## ORIGINATION FORM

### Proposed Revisions to a Standard Plans Index

Index Number: 639-001

Index Title: SERVICE POINT DETAILS

LAST REVISION	DESCRIPTION:	 FY 2023-24 <del>23-24</del> 24-25 STANDARD PLANS	SERVICE POINT DETAILS	INDEX	SHEET
11/01/17	11/01/23			639-001	1 of 2

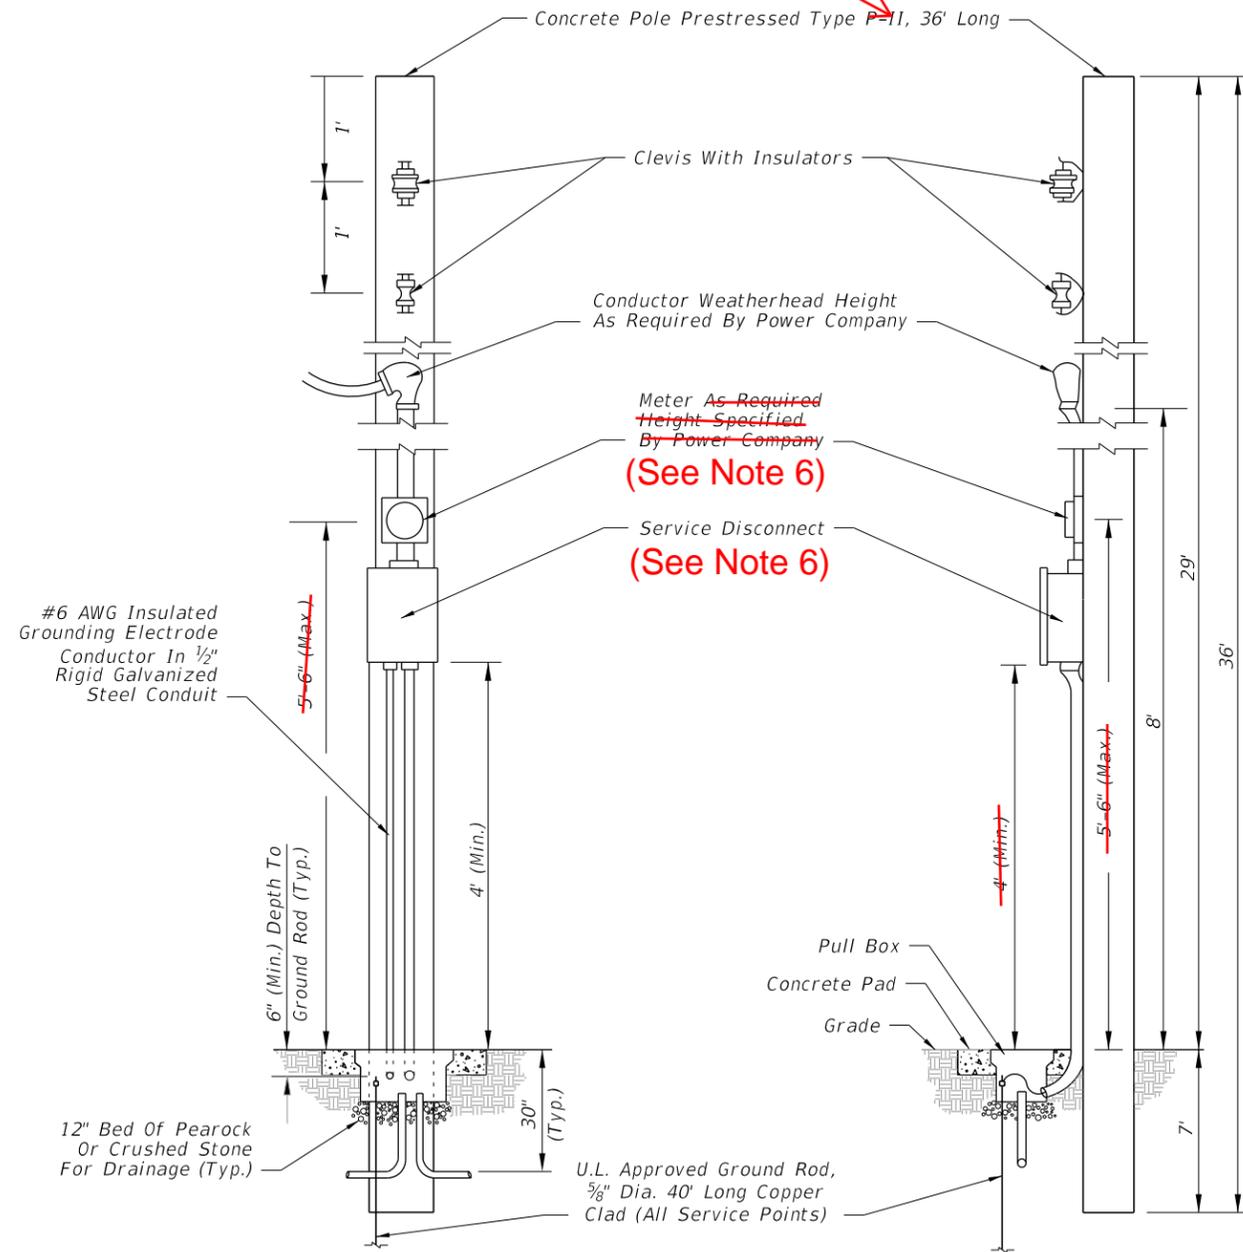
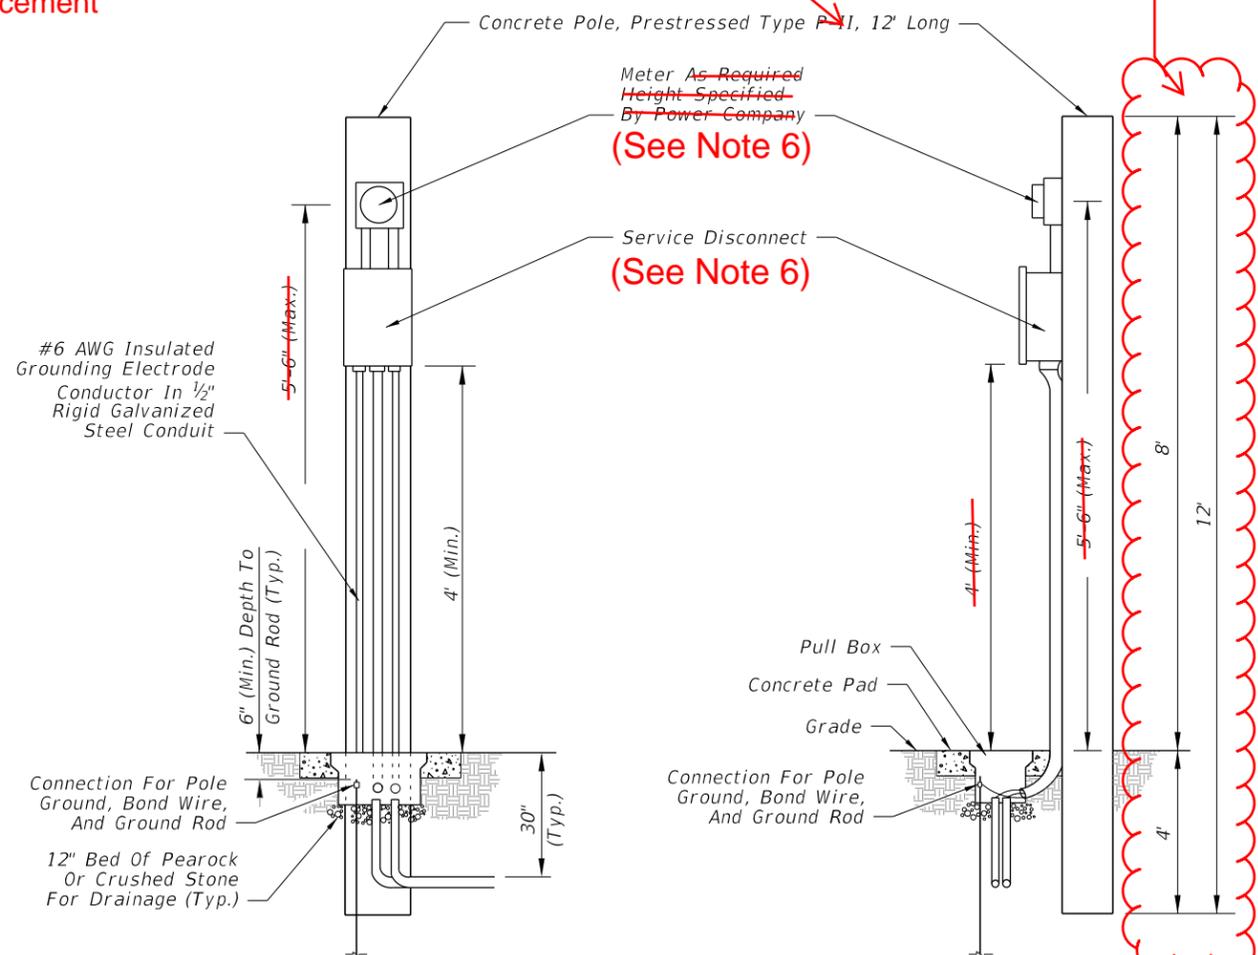
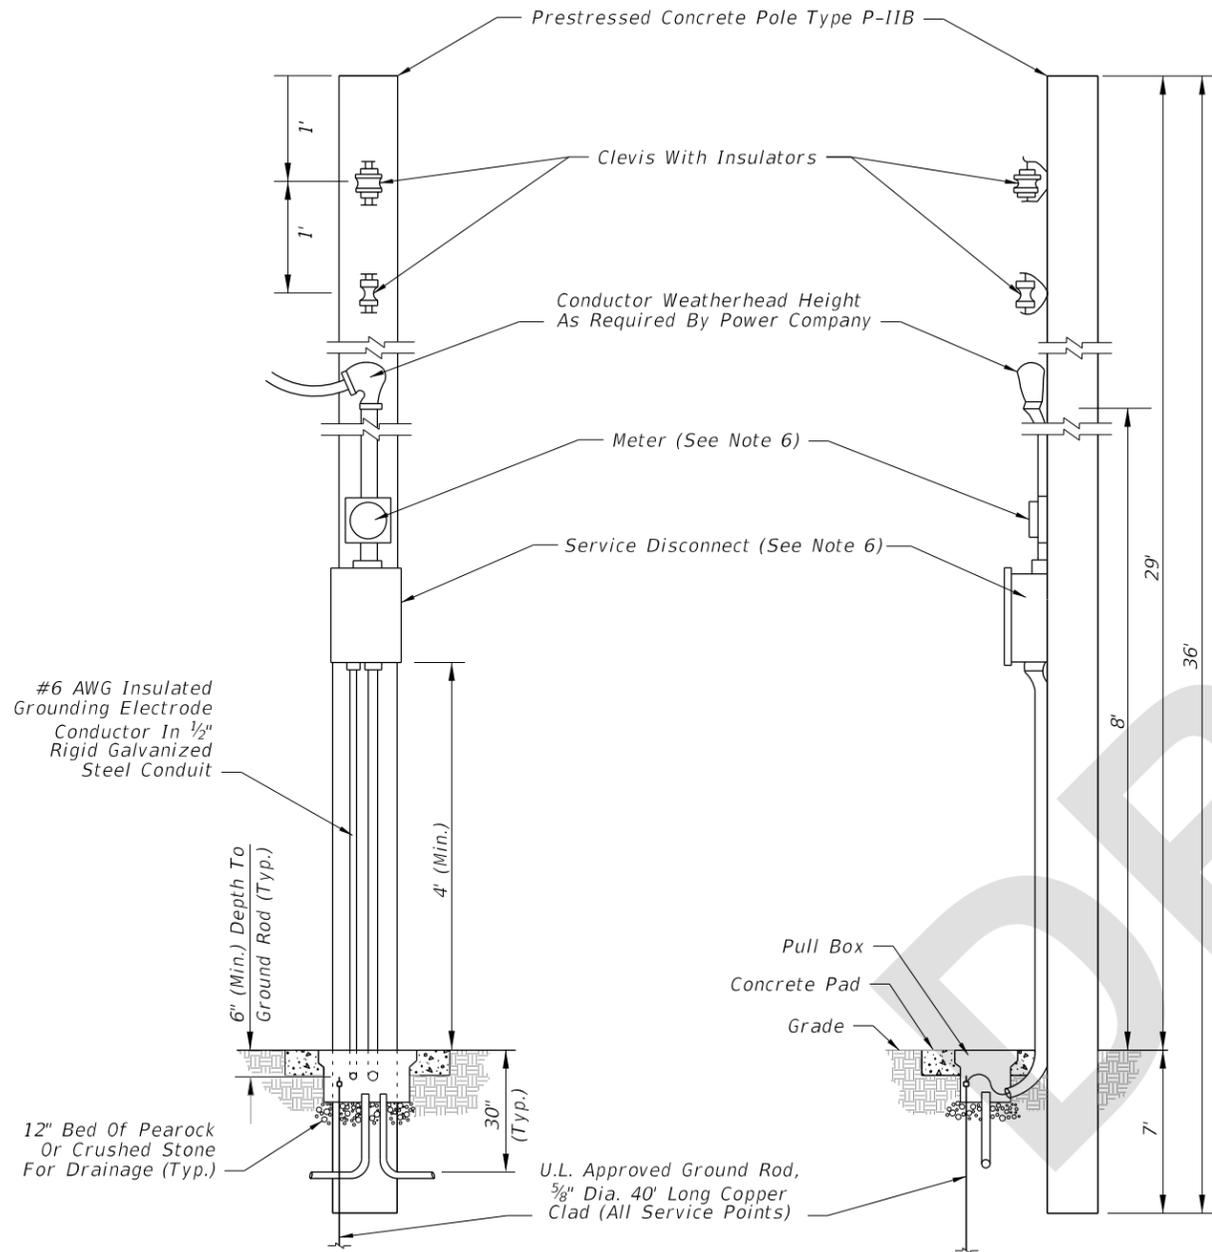
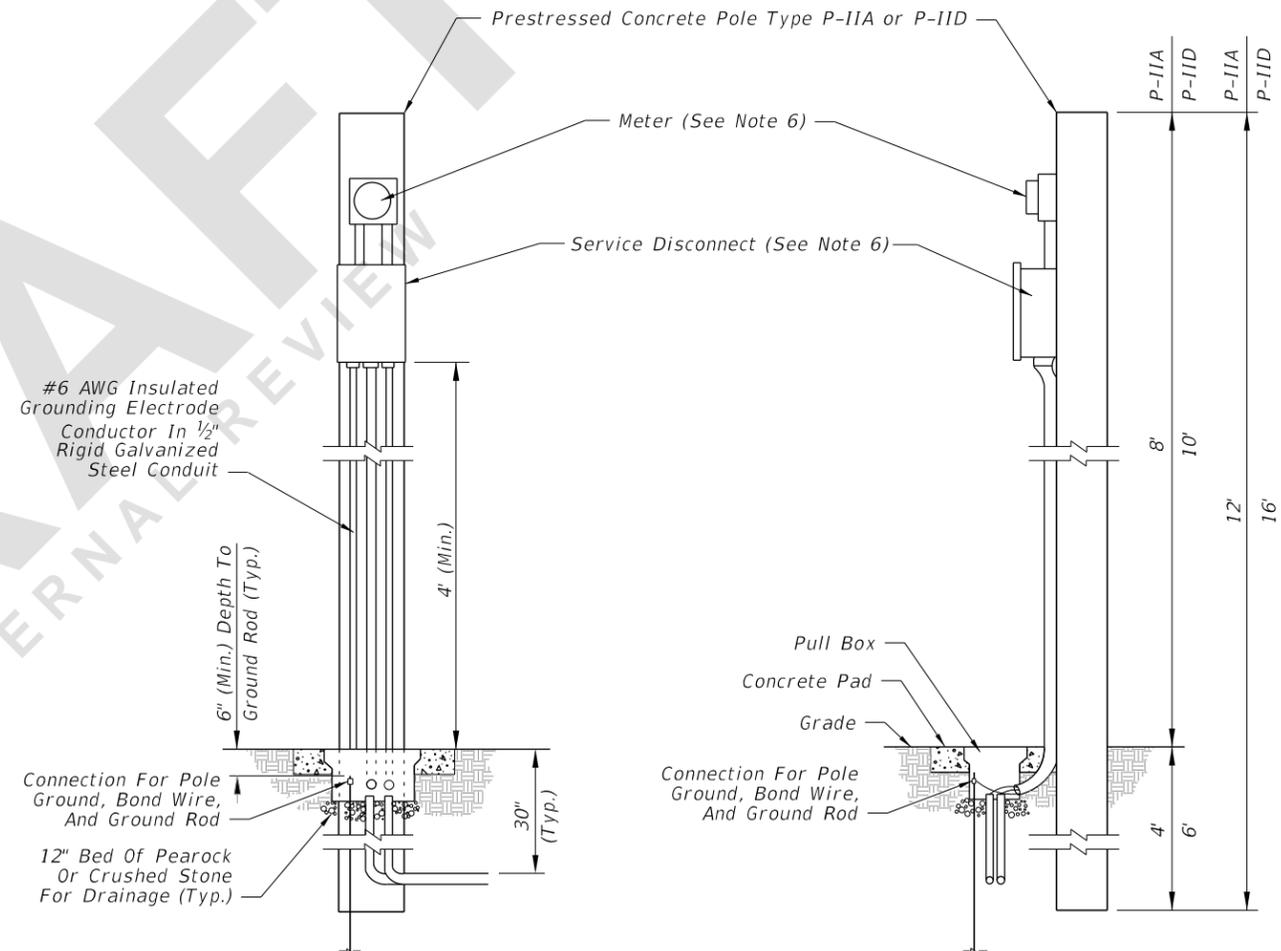
Added pole dimensions for the new Type P-IID concrete pole option in Detail B.

Removed height dimensions for the meter and service disconnect in Details A and B;

Added reference to Note 6 in the meter and service disconnect callouts in Details A and B;

Added Note 5 to reference Index 641-010 for prestressed concrete pole details and explain optional pole usage;

Added Note 6 to provide height information for the meter and service disconnect

Reworded, added specific "Type P-IIB"

Added note 5 for prestressed concrete pole details and usage

Added note 6 for meter and service disconnect height placement

Reworded, added specific "Type P-IIA & P-IID"

Added dimensions for pole types P-IIA & P-IID

Per District request, the 16-foot concrete pole (Type P-IID) was recently added to Index 641-010 in the FY2023-24 Standard Plans. As a result, this new 16-foot pole option will now be accommodated in Index 639-001.

Leeway is provided for the raised height of the meter and service disconnect to allow for project-specific District and power company needs.
